UNITED STATES PATENT AND TRADEMARK OFFICE

10/736,945

Office Action Summary	Application No. 10/736,945	Applicant(s) GESCHWINDT ET AL.	
	Examiner MARIA J. LAIOS	Art Unit 1795

DETAILED ACTION

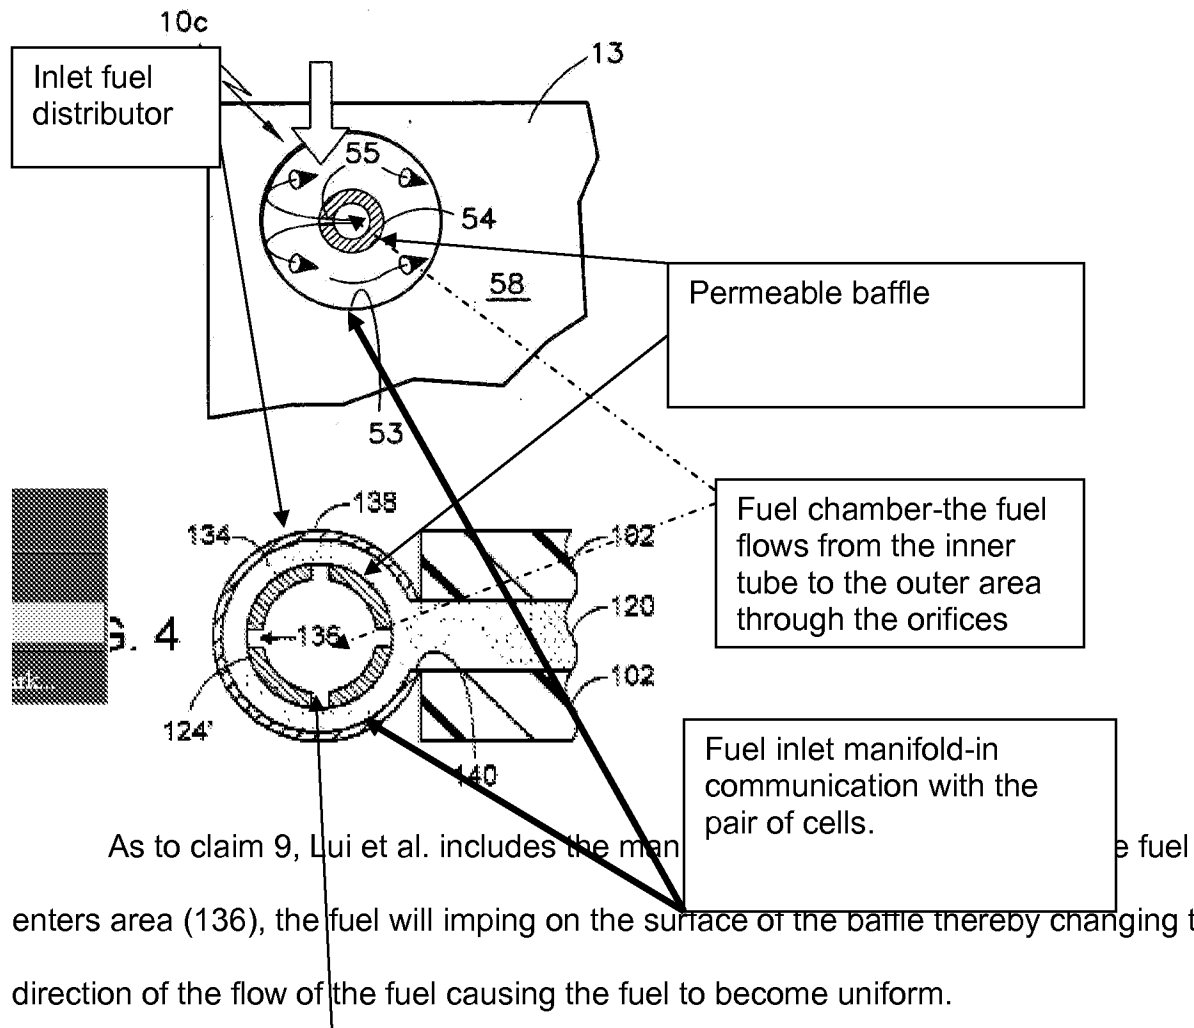
As to claims 2 and 4, Lui et al. discloses a fuel cell system comprising a pair of cells (Paragraph 26). Each of the cells will inherently have a fuel flow field and a fuel inlet and a fuel supply pipe. (See Figures below for a comparison match between applicants figure of the elected specie and Lui et al. figure)

As to claim 12, the fuel inlet distributor comprises a first internal manifold receiving fuel from the fuel supply pipe (area 136) a second internal fuel manifold (area 134) providing fuel to the fuel inlets and receiving fuel through the permeable baffle from the first internal fuel manifold (figure above).

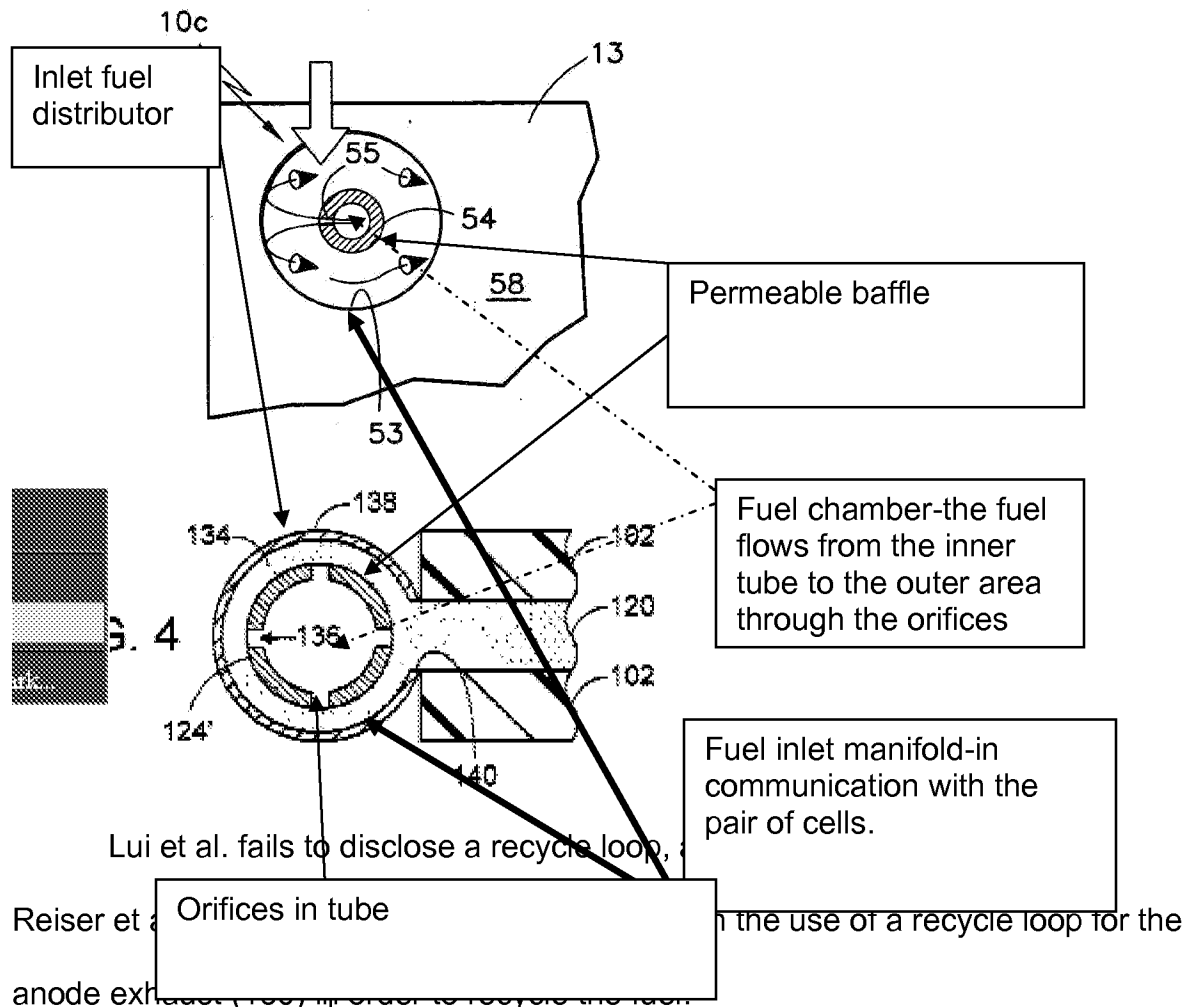
As to claim 14, Lui et al. disclose a plurality of fuel cells, each of the fuel cells have at least one fuel flow field and a fuel inlet and fuel outlet. Each of the cells will inherently have a fuel flow field and a fuel inlet and a fuel supply pipe. (See Figures below for a comparison match between applicants figure of the elected species and Lui et al. figure)

However Lui modified by Reiser fail to disclose the recycled fuel is provided down stream of the permeable baffle.

It would have been obvious to one of ordinary skill in the art at the time of the invention to replenish the fuel in the system because it would save the fuel from being expended. Furthermore the placement of the fuel downstream of the baffle would allow the recycled fuel to enter the cells directly and would further mix with the fuel entering from the orifices thus homogenizing the fuel entering the cells.

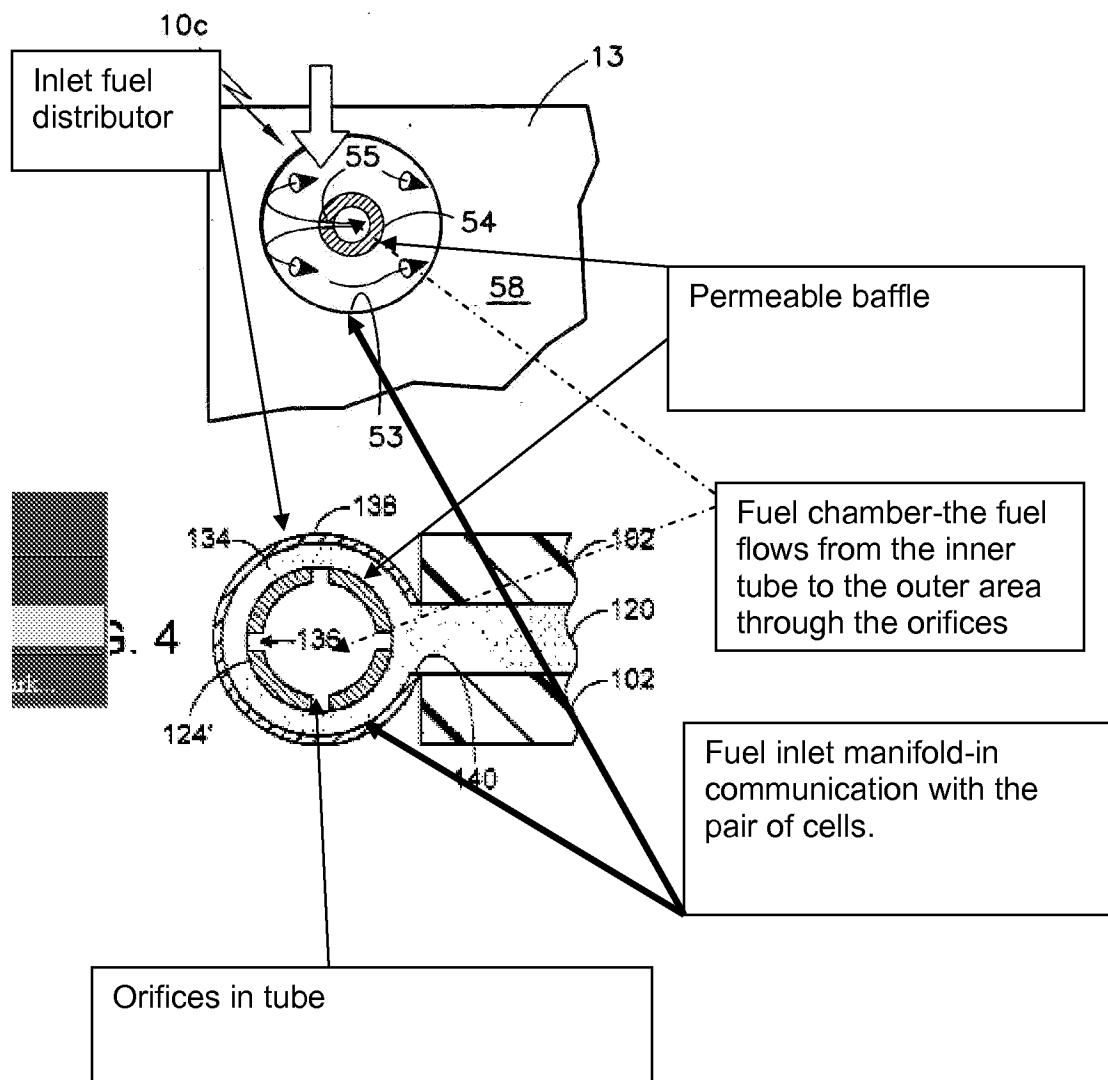
As to claim 1 and 13, Lui et al. disclose a plurality of fuel cells, each of the fuel cells have at least one fuel flow field and a fuel inlet and fuel outlet. Each of the cells will inherently have a fuel flow field and a fuel inlet and a fuel supply pipe. (See Figures below for a comparison match between applicants figure of the elected specie and Lui et al. figure)

Lui et al. fails to disclose a recycle loop, an exhaust valve or a controller.

Reiser et al. discloses a fuel cell system and teach the use of a recycle loop for the anode exhaust (150) in order to recycle the fuel.

However Lui modified by Reiser fail to disclose the recycled fuel is provided down stream of the permeable baffle.

It would have been obvious to one of ordinary skill in the art at the time of the invention to replenish the fuel in the system because it would save the fuel from being expended. Furthermore the placement of the fuel downstream of the baffle would allow the recycled fuel to enter the cells directly and would further mix with the fuel entering from the orifices thus homogenizing the fuel entering the cells.

Reiser further discloses a valve (170) which is in fluid communication with the cells and is upstream from the manifold inlet. Since the valve is downstream of the exiting gas it will be located a distance from the interconnection of the fuel inlet chamber and the supply pipe. It would have been obvious to one of ordinary skill in the art to include a valve in the recycle system in order to control the amount of fuel being recycled.

Lui et al. modified by Reiser fail to disclose a controller controlling the valve. LaPierre et al. disclose a controller (150) for controlling the valves during start up. It would have been obvious to one of ordinary skill in the art at the time of the invention to include the controller of LaPierre et al. to the system of Lui modified by Reiser because the controller can adjust the valve to control the flow rate of the fuel (col. 17 lines 57- col. 18 line 5).
